# Modification of Development Consent

<b>Development consent:</b>	MP 08_0184 granted by the Minister of Planning on 15 November 2010
<b>For the following:</b>	Ulan Continued Operations Project
<b>Applicant:</b>	Ulan Coal Mines Pty Limited
<b>Consent Authority:</b>	Minister for Planning
<b>The Land:</b>	Refer to Appendix 1 of MP 08_0184
<b>Modification:</b>	MP 08_0184 MOD 7: Alternative biodiversity offset site

Offset and Management Areas

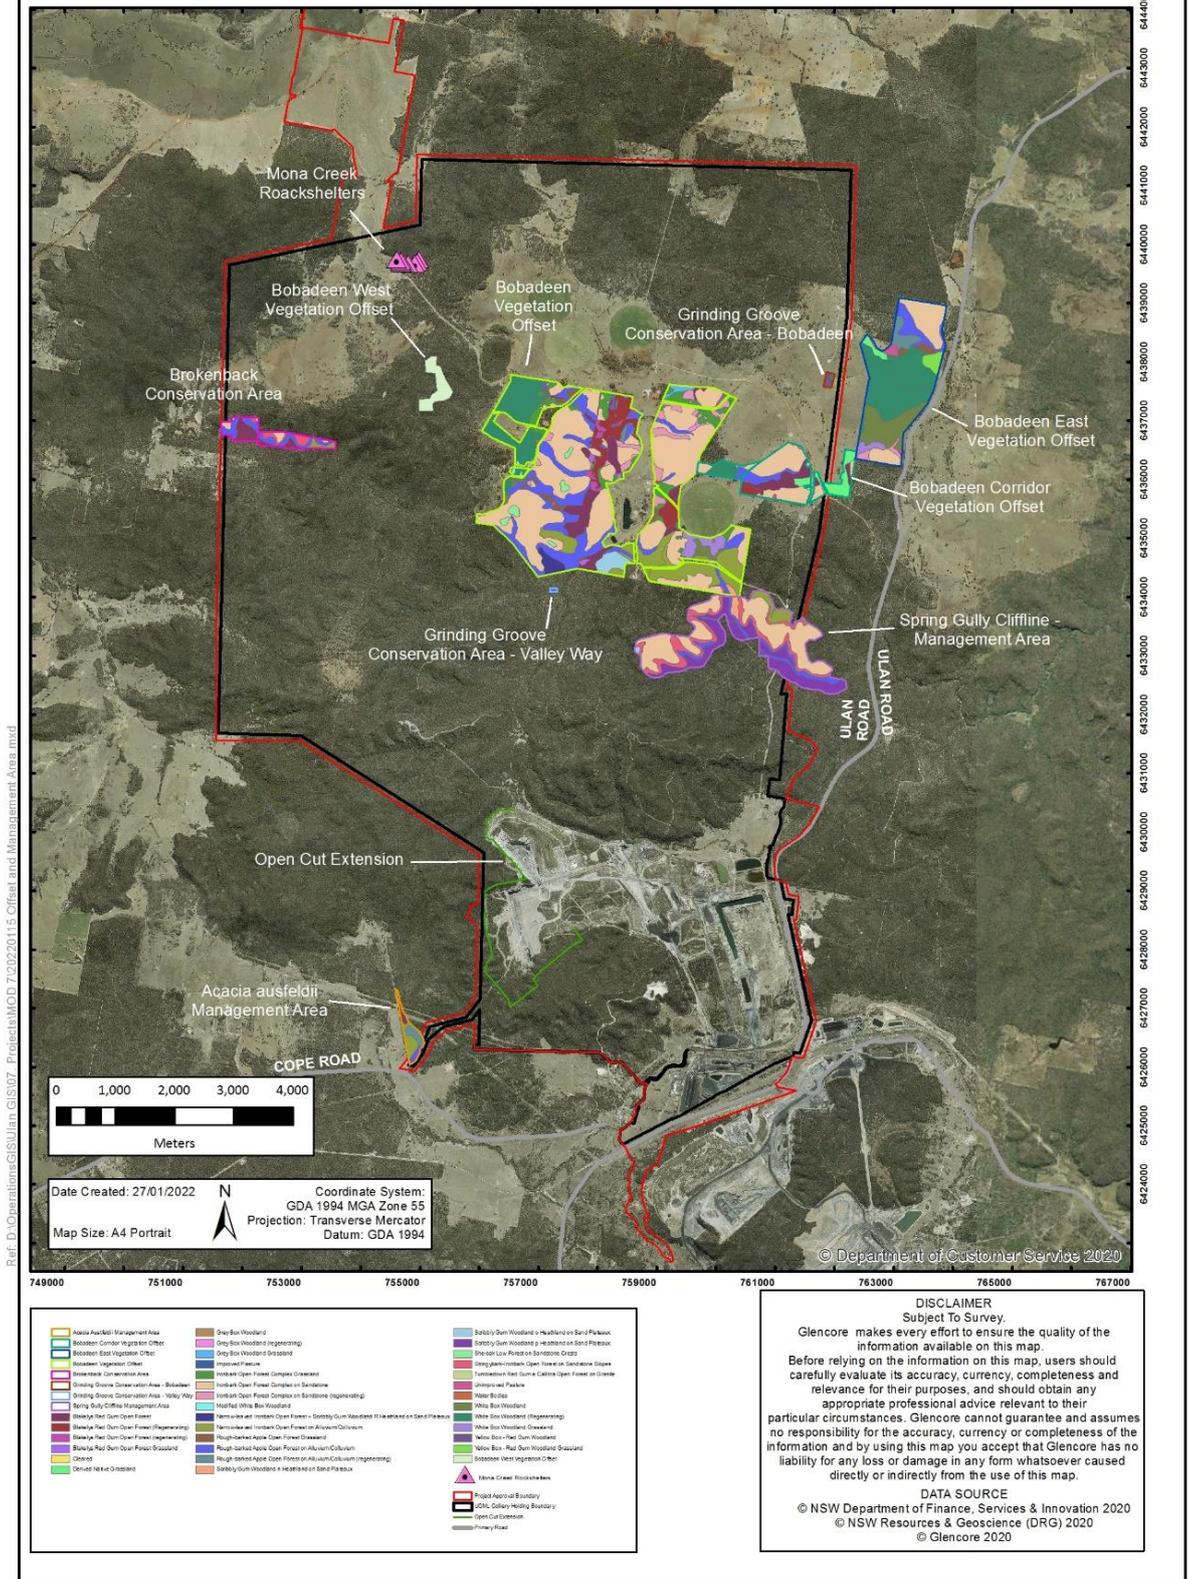
43AA. Unless otherwise agreed by the Secretary, the Applicant must make suitable arrangements to provide appropriate long term security for the Bobadeen West Vegetation Offset Area to the satisfaction of the Secretary by 30 June 2023.
16. In Schedule 3 condition 55, delete the words “to the satisfaction of DRG” and replace with “in accordance with the conditions imposed on the mining lease(s) associated with the development under the *Mining Act 1992*”
17. In Schedule 3 condition 57, delete the words “to the satisfaction of Secretary Industry” and replace with “in accordance with the conditions imposed on the mining lease(s) associated with the development under the *Mining Act 1992*”
18. In Schedule 3 condition 57(f), delete “DRG” and replace with “the Secretary”
19. In Appendix 4 Offset Strategy, delete the figure and insert the following figure:
